# Access Compliance Report

## Public Rights-of-Way

### (Curb Ramps)

Intersection ID: N/A	Main Street: RAKU_CT	Cross Street: N/A	Location: NW
ADA ID: 9B0B7875357C	Ramp Type: Perp	Initial Pass/Fail: Fail	Overall Compliance: No
		Severity Score: 25

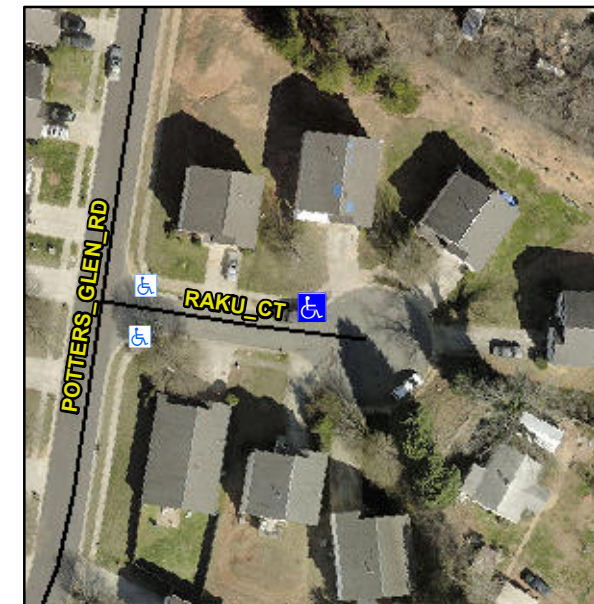
Compliance	Description	Data	Compliance	Description	Data
N/A	Ramp Length (in)	48.0	Yes	Ramp Slope (%)	7.7
Yes	Ramp Width (in)	48.0	No	Ramp XSlope (%)	7.1
N/A	Flare Type LT	N/A	N/A	Flare Type RT	N/A
N/A	Flare Slope LT (%)	N/A	N/A	Flare Slope RT (%)	N/A
N/A	Flare Traversable LT?	N/A	N/A	Flare Traversable RT?	N/A
N/A	Landing Length (in)	N/A	N/A	DWS Provided?	N/A
N/A	Landing Width (in)	N/A	N/A	DWS Contrast?	N/A
N/A	Landing Slope (%)	N/A	N/A	DWS Length (in)	N/A
N/A	Landing X Slope (%)	N/A	N/A	DWS Full Width?	N/A
N/A	Landing Curb? (Y/N)	N/A	N/A	DWS Offset (in)	N/A
N/A	Shared Landing?	N/A			
N/A	Gutter Ponding?	N/A	N/A	Gutter Slope (%)	N/A
N/A	Gutter Lip Ht (in)	N/A	N/A	Gutter X Slope (%)	N/A
N/A	Painted X Walk1?	No	N/A	Painted X Walk2?	N/A
	X Walk 1 Direction	To S		X Walk 2 Direction	N/A
N/A	X Walk 1 Width (in)	N/A	N/A	X Walk 2 Width (in)	N/A
	X Walk 1 Slope (%)	5.0		X Walk 2 Slope (%)	N/A
	X Walk 1 X Slope (%)	8.1		X Walk 2 X Slope (%)	N/A

**Remove & Replace Entire Ramp.**
